ValenceTech Limited

iBT-03 Bluetooth Module

Rev. 02

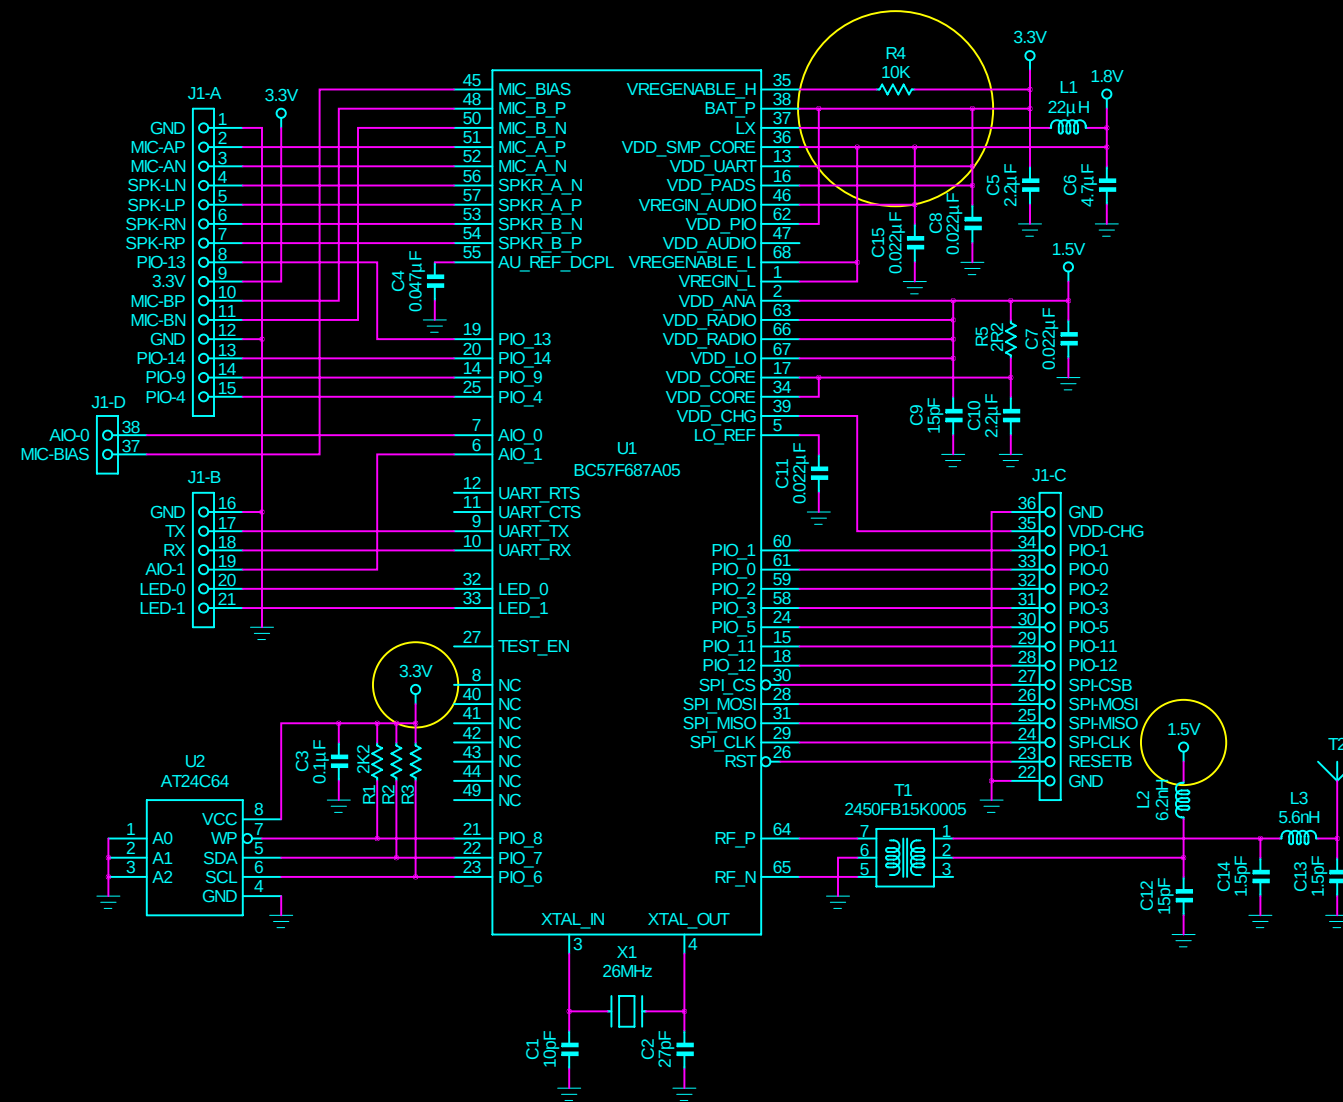
1. U1 pin 13 VDD_UART powered from 3.3V (old design is 1.8V)
2. U1 pin 16 VDD_PADS powered from 3.3V (old design is 1.8V)
3. U1 pin 62 VDD_PIO powered from 3.3V (old design is 1.8V)
4. U2 pin 8 powered from 3.3V (old design is 1.8V)
5. L2 pin 2 powered from 1.5V (old design is 1.8V)
